PLANNED UNIT DEVELOPMENT STAFF REPORT

Date: November 7, 2013

DEVELOPMENT NAME	Dolphin Storage, LLC
LOCATION	2715 Dauphin Street (South side of Dauphin Street, 67'± East of Dauphinwood Drive)
<u>CITY COUNCIL</u> <u>DISTRICT</u>	District 1
PRESENT ZONING	B-3, Community Business District
AREA OF PROPERTY	6.7± acres
CONTEMPLATED USE	Planned Unit Development Approval to amend a previously approved Planned Unit Development Approval

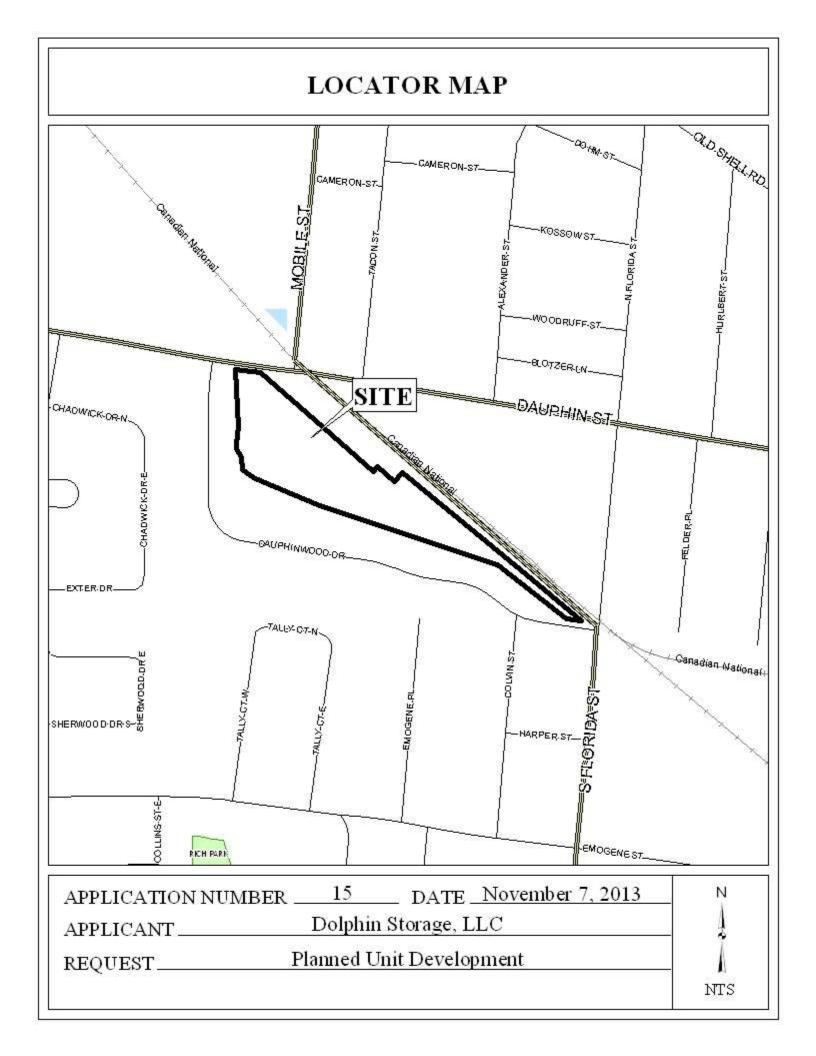
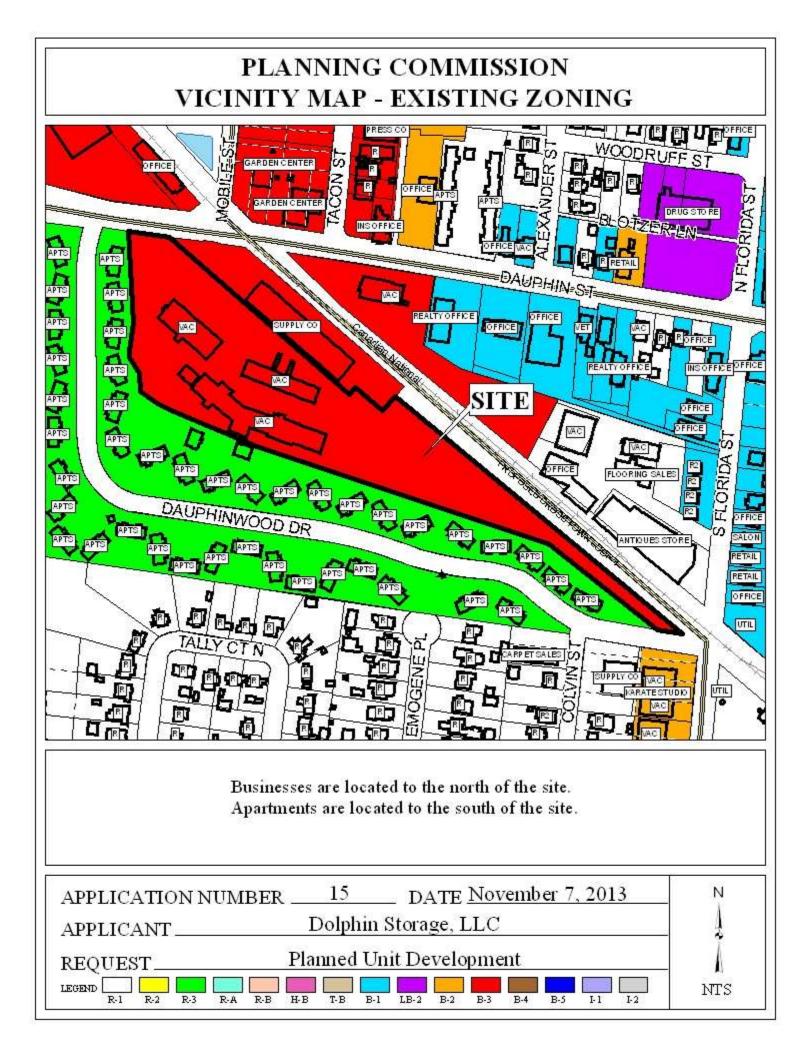
While the current request is similar to the approved 2012 PUD, it appears that the number of proposed buildings and layout of the proposed site is different. The current site plan illustrates:

- 1) 3 existing buildings totaling $40,000\pm$ sf;
- 2) $26,220\pm$ sf of new additions which include 9 proposed buildings and 1 canopy; and
- 3) 51 parking spaces for RVs and boats ranging from a depth of 25 to 50'.

The current site plan does not indicate:

- 1) The number of storage units;
- 2) Buffering and landscaping requirements;
- 3) The location of the office and required parking spaces; and
- 4) A dumpster, if provided.

Furthermore, the site plan indicates gravel parking for the proposed RV/ boat storage area. It is important to note that a gravel parking surface is not allowed in a B-3, Community Business District, thus if the applicant desires to use gravel as a parking surface, a Variance Application submitted to the Board of Zoning Adjustments will be required. Otherwise, a revised PUD site plan should be submitted to illustrate a paved parking surface throughout the entire site.

It should be pointed out that the site plan illustrates two curb-cuts to Dauphin Street; therefore, the revised site plan should only depict one curb-cut.

Through the use of historical aerial imagery, it appears that a $1400\pm$ sf building and two 350' \pm structures were removed within the past 3 years. It should be pointed out that demolition permit was not obtained and therefore, an after the fact demolition permit should be required.

<u>RECOMMENDATION</u> Planned Unit Development: The application is recommended for Holdover to the December 5, 2013 meeting with revisions due by November 15, 2013 to address the following:

- 1) Obtainment of an after the fact demolition permit;
- 2) Revision of the site plan to depict the number of storage units;
- 3) Revision of the site plan to show the location of the office and all required parking spaces to ensure circulation is adequate;

- 4) Revision of the site plan to illustrate the location of a dumpster in compliance with Section 64-4.D.9. of the Zoning Ordinance;
- 5) Revision of the site plan to illustrate only one curb-cut to Dauphin Street;

- 6) Revision of the site plan to illustrate a paved parking surface throughout the entire site or the submission of a variance application for a gravel parking surface in a B-3, Community Business District. (*Please note that if the applicant desires gravel parking, the approval of the revised site plan which depicts a gravel parking surface for the RV*/ *boat area is contingent to the approval of the Variance Application.*);

- 7) Revision of the site plan to comply with buffering and landscaping requirements to include the illustration of a 10-foot buffer along the adjacent residentially zoned property, in conjunction with the 3-foot solid hedgerow along the 25-feet minimum building setback line of Dauphin Street;

- 8) Placement of a note on the site plan stating that lighting on the site must comply with the requirements of Sections 64-4.A.2. and 64-6.A.3.c. of the Zoning Ordinance; and

- 9) Placement of a note on the site plan stating that the site is denied access to Dauphinwood Drive and is to be limited to one curb cut to Dauphin Street with the size, location, and design to be approved by Traffic Engineering and conform to AASHTO standards.
